# DeKalb County Historic Preservation Commission

## Staff Report

G. 1946 Edinburgh Terrace, Amina Bhatia. Replace windows on a historic house. **1247463**

Window replacement - sunporch  
1946 Edinburgh Ter NE, Atlanta, GA 30307

Photo 1.\_ Exterior view of the house, showing current window placement in the front

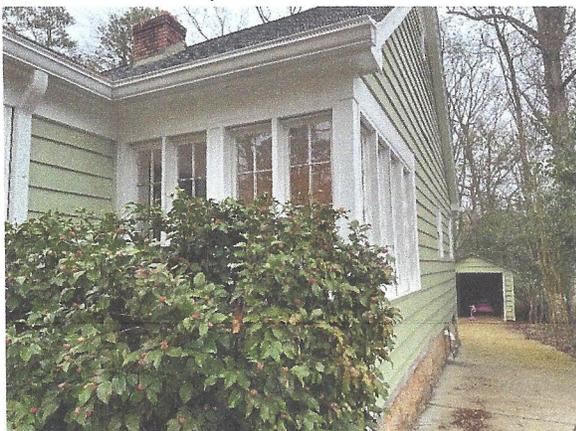
The applicant proposes replacing a total of eight (8) windows on a historic house. This includes four (4) wood single pane windows on the front façade of the house and four (4) single wood windows on the right elevation of the house, each with a simulated 8-dived lite design, around the sunroom of the house. The other windows on the front façade of the property were approved to be and previously replaced in 2021. The windows will be replaced in kind with wood casement windows with the same simulated 8-divided lite pattern as the original windows.

Approve. These proposed changes do not appear to have a substantial adverse effect on the district. This application appears to meet the guidelines and the staff recommends approval.
